Reviewing request of Owner, Alex Delendik, to a Vacant Building Registration Notice at 827 AGATE STREET.

Project: Review of Constructed Retaining Wall
827 Agate St.
St. Paul, MN
PEC #6186

8" BLOCK WALL OPTION

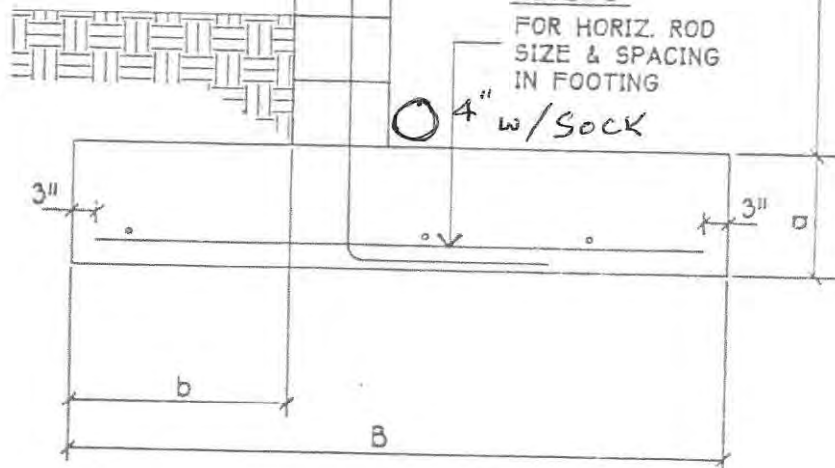
This report concerns our review of a constructed retaining wall behind the front sidewalk at 827 Agate St., St. Paul, MN. The property owner, Alexander Delendik, of Homestead Road LLC, performed his own construction of the wall in general conformance with a detail sheet entitled "8" Block Wall Option." However, the inspection department at the City of St. Paul required that the wall be inspected by a Registered Engineer who could answer to the construction requirements outlined in its identification sheet.

Over the last several weeks, the old retaining wall was demolished and the footing construction removed from the front stairway eastward to the east property line. This amounted to a retaining wall length of slightly less than 30', since a higher concrete retaining wall had been left in place to the west of the stairway. A new footing was dug in behind the sidewalk, providing a new footing which was approximately 12" deep and at least 32" from the existing front sidewalk toward the rear of the property. Reinforced concrete used $\frac{1}{2}$ " rebar for the longitudinal steel in three locations at the front of the footing, the rear of the footing, and half-way between these bars. The front and rear bars used a 3" cover of concrete to the dirt forms. The first course of 8" block was placed

in the wet concrete and the footing was stabbed with $\frac{1}{2}$ " bars spaced 20" on center toward the rear face of the concrete block first course.

Using this layout of block and rebar, successive courses of 8" concrete block, both double corner and common, were placed with a mason's mortar using a common bond pattern to top of wall height. The completed wall was approximately 4-1/2 courses in height. The vertical rebar were left at least 2 to 3" below top of wall. The completed wall section was then filled with a 4000 psi curb and gutter mix. The rear of the wall received a 4" corrugated drain tile with an exterior sock. The backfill material behind the wall was filled with a granular backfill material and then capped off with the natural excavated soils which consisted of a silty sand material with topsoil mix. The entire backfill region behind the wall was estimated as less than a 33% grade, and the entire backfill area received a grass mix and was covered by a straw mulch.

Since the entire project was completed just recently, the owner will also reseed in the springtime and will seed as needed for a grassy embankment. Based on our observations, the owner has protected the finished grade as much as possible and will continue with seeding and mulching this spring to establish a lawn. We informed the owner that such embankments should drain over the top of the wall and not behind the wall for maximum stability of the wall construction. It is our opinion the owner has used good workmanship on this construction.
